Technical Service Information

FORD 4F27E

GEAR RATIO CHANGE

Figure 1

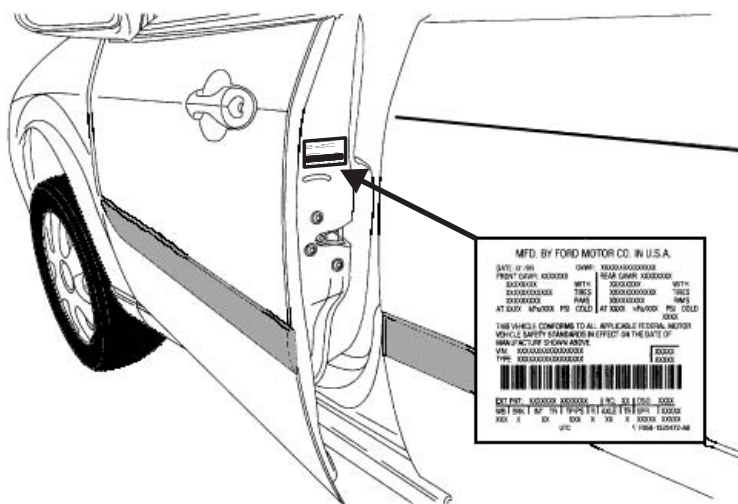
Locate the Vehicle Verification Label (VCL), (Refer to Figure 1), in order to know which gear ratio the transaxle originally had.

Figure 2

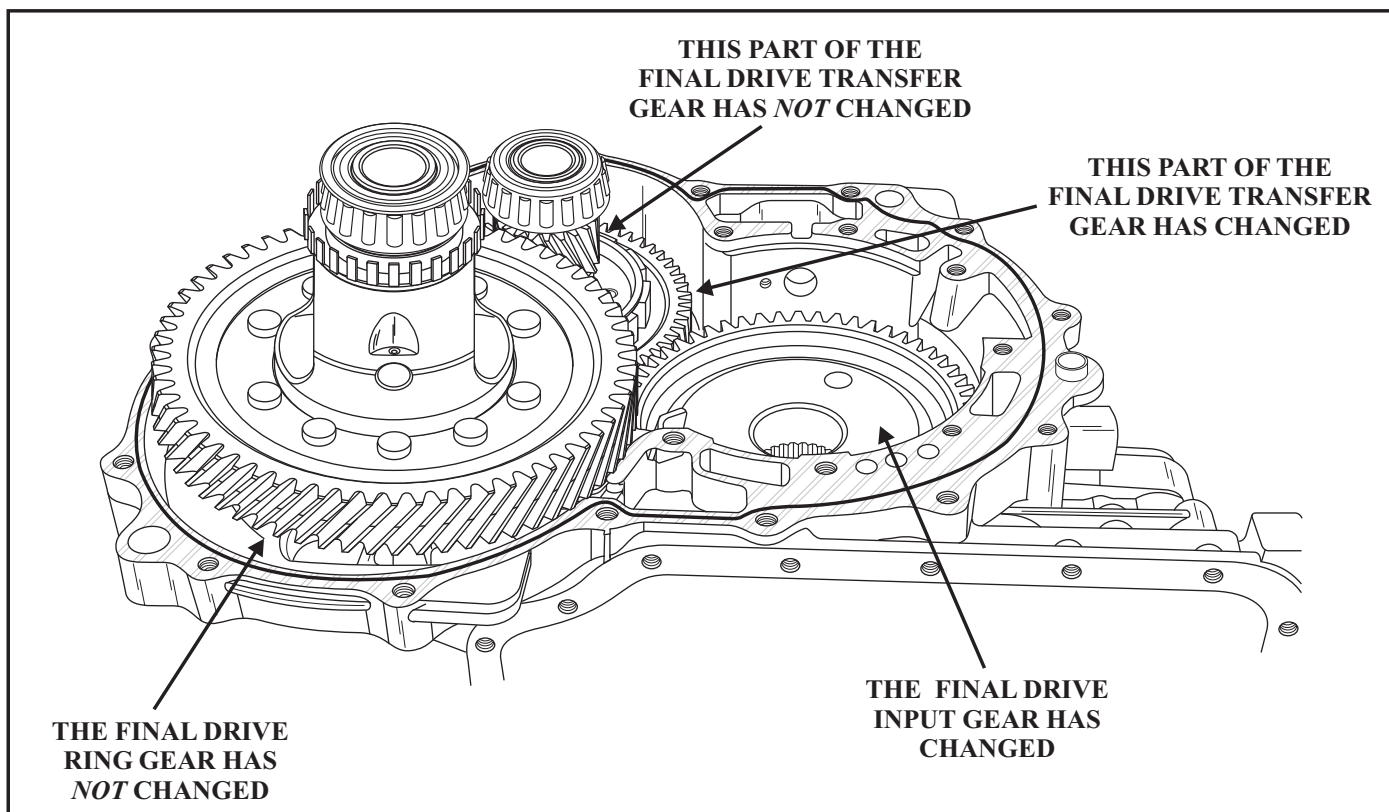
An example of the VCL can be seen in Figure 2. The location of the axle code is shown as well as the previous and current axle codes and gear ratios. The previous gear ratios are no longer available.

NOTE: These are the two previous gear ratios used for North American applications with automatic transmission
 NN = 3.693 Automatic
 WW = 3.904 Automatic

NOTE: These are the two current gear ratios used for North American applications with automatic transmission
 *PP = 3.733 Automatic
 *XX = 3.956 Automatic
 *Could also be JJ or ZZ

Figure 3

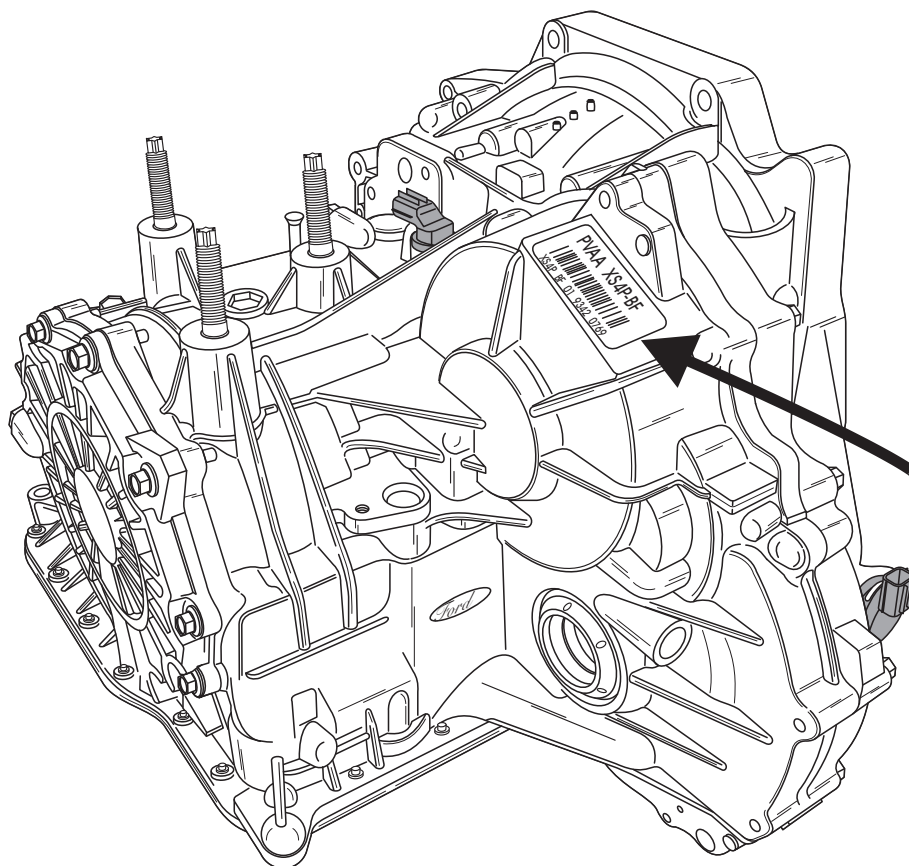
- (1) The final drive input gear tooth count has changed from 87 to 59 teeth.
- (2) The transfer shaft input gear tooth count has changed from 83 teeth to 57 teeth. The final drive ring gear and its mating gear on the input transfer gear have *not* changed as shown in Figure 3.
- (3) A new PCM calibration was made available to accommodate the new gear ratio. An authorized PCM modification label (Refer to Figure 4) should be placed near the vehicle emission label.
